TB 192

TECHNICAL BULLETIN

For the Attention of:	Service Engineers, Platform Lift Installers, Trade Customers, Export Customers, Training Dept, Spares Dept.
Date:	11/01/2024
Product:	Stannah Midilift SL & GL (hydraulic open platform lifts) manufactured from September 2009.
Subject:	Engagement between pit prop and underside of platform
Pages:	5

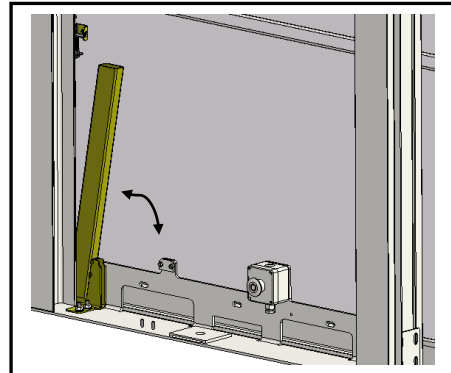
The design of the pit prop on the Stannah-manufactured Midilift SL and GL platform lift has remained largely unchanged since its inception in 2009. A recent review of the arrangement has uncovered that it is theoretically possible to have insufficient engagement between the activated pit prop and the underside of the platform due to on-site adjustments and variables in manufacturing.

For this reason, no person(s) should occupy the lift pit on the affected products until an inspection has been conducted to verify that the pit prop leg has sufficient engagement with the underside of the platform (i.e. 10mm min) when in the activated position

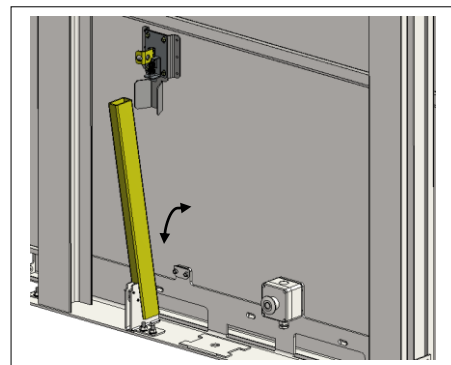
This bulletin relates to Stannah Midilift SL & GL (hydraulic open platform lifts) manufactured from Sept 2009 to August 2023 where the operation of the pit prop is parallel to the guide rails.

Exemptions: This bulletin *does not apply* to Midilift SL & GL models manufactured between June 2012 to March 2015 where the operation of the pit prop is perpendicular to the guides.

Clamp extension bracket - retrofit kit
Stannah Lifts part no. 6104120

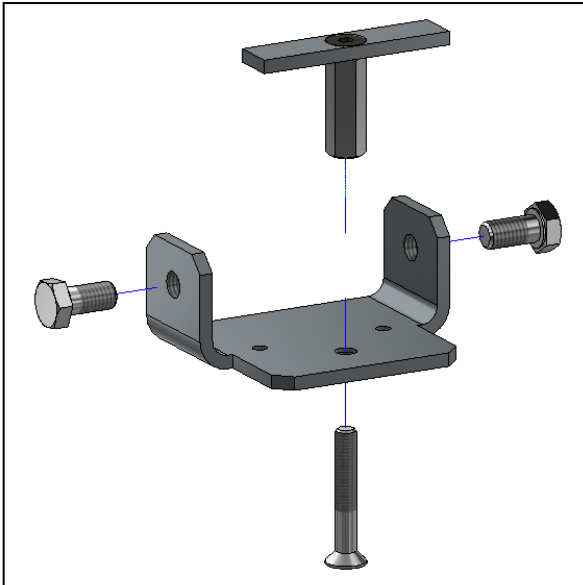
A clamp extension bracket is available for retrofitting on site when the pit prop engagement is found to be less than 10mm. This clamp is to be fitted to the platform, requires no drilling and can be installed in a few minutes (see images below).

Clamp extension bracket assembled to
platform to increase engagement between
pit prop and underside of platform.

The clamp extension bracket must be assembled from the platform deck using steps 1 to 5 in Section 3.

After fitting re-check that the pit prop engagement is at least 10mm minimum.
